# Washington Public Power Supply System

Docket No. 50-508

Subject: NRC INSPECTION AT WNP-3  
DEVIATION (50-508/82-10)  
MASONRY BLOCK WALL - FAILURE TO CONSTRUCT  
IN ACCORDANCE WITH QUALITY CLASS I

DEVIATION (50-508/82-16/03)  
MASONRY BLOCK WALL - FAILURE TO CONSTRUCT  
IN ACCORDANCE WITH QUALITY CLASS I

WASHINGTON PUBLIC POWER SUPPLY SYSTEM  
NUCLEAR PROJECT NO. 3 & 5  
TYPICAL DETAILS OF MASONRY  
WALL REINFORCING

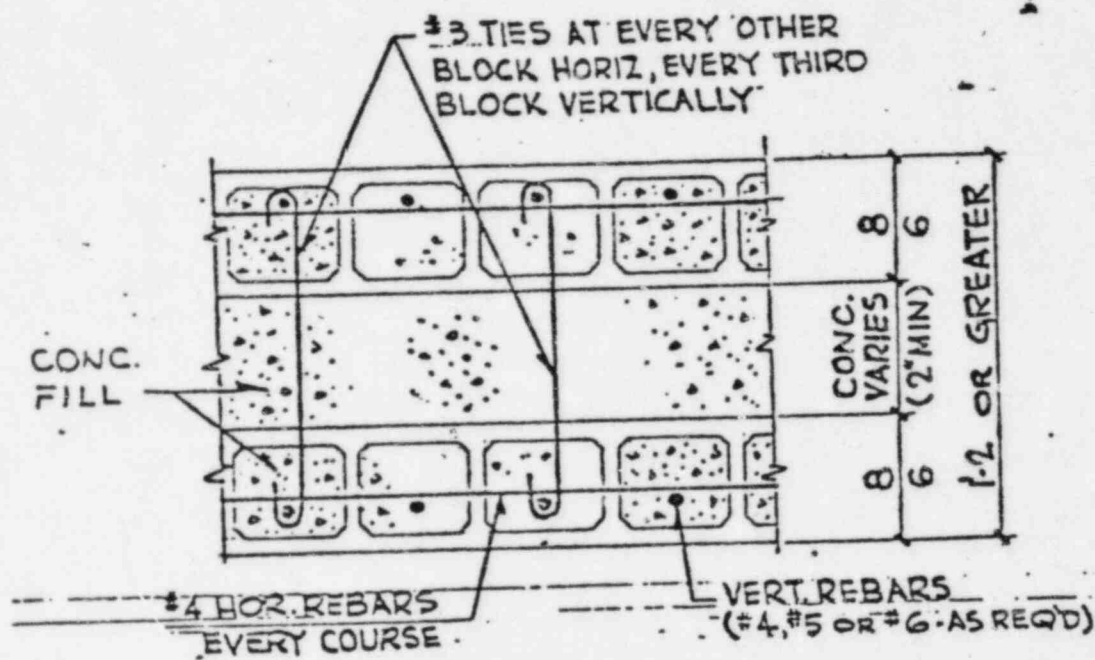
Contrary to the above, a masonry block wall 23 feet 1 inch high was installed approximately 6 feet from nuclear safety related Diesel Generator Control Panel "A". Failure of this wall during a seismic event may disable the "A" diesel generator. The wall was classified as WPPSS Quality Class G and therefore was installed as a non-safety related structure not subject to the requirements of the licensee's quality assurance program required by 10CFR50, Appendix B.

REVIEW FOR BLOCK WALL (NO. 41) ACCEPTABILITY

To determine the safety significance and acceptability of the wall in question, a detailed review was conducted by Ebasco. Results of the review are summarized as follows:

- All concrete block walls in the RAB have been seismically designed for the SSE using loads derived from the maximum building accelerations at the installed elevation of the block walls.

It has been concluded that, even though the bonding mortar and concrete fill do not meet the requirements of Quality Class I, the wall in question is acceptable based on: 1) the available records of inspection; 2) material tests performed to date; and 3) prism tests performed and in process. In addition, it is considered that, with the exception of mortar and grout, the design and construction of all masonry block walls in the RAB are in compliance with the Supply System's response to the NRC regarding IE Bulletin 80-11 (Reference Letter G03-81-854, dated March 25, 1981).

- 1) Inspection by the Engineer during construction will be strengthened by issuance of a Resident Engineering Instruction that will provide more detailed inspection criteria. In addition, a standard reporting format for documenting these instructions will be adopted.
- 2) All concrete block walls previously installed in seismic zones and for which neither "Concrete Tracking Records" nor "Concrete Block Wall Construction Forms" exist (i.e., wall Nos. 45, 60, 64 and 66 at RAB EL 390) will be examined using metal detection methods to independently confirm the inclusion of reinforcing steel.
